Re: Response to Correspondence 30715 for FCC ID: AZ489FT5848 with Confirmation Number EA461977.

Motorola Inc., 8000 West Sunrise Boulevard, Fort Lauderdale, Florida 33322, herein submits its response to the 19th April 2006 Request for Information on FCC ID: AZ489FT5848, EA461977 via Correspondence Number 30715.

Ambient Noise Response

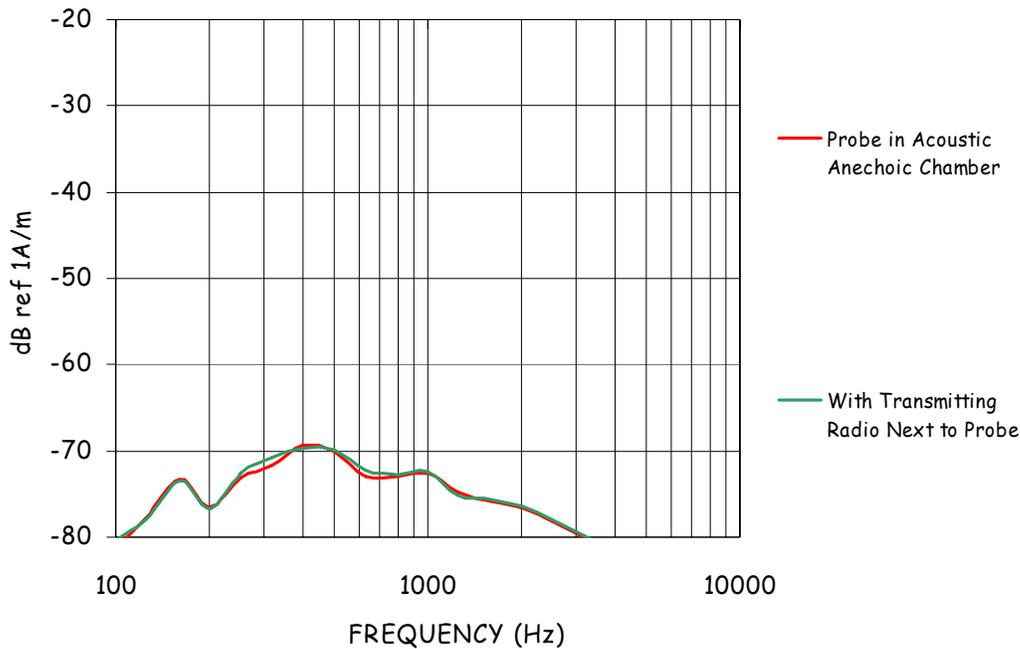
Q11. Please demonstrate that RF emissions from the phone do not effect the T-coil measurements.

The graph below shows two ambient noise level responses. The baseline is the probe in the anechoic chamber by itself, and then a phone in a call placed next to the probe. The results show that there is negligible interference reflected in the measurement system with respect to the presence of the RF emissions, and as such the T-coil data were unaffected.
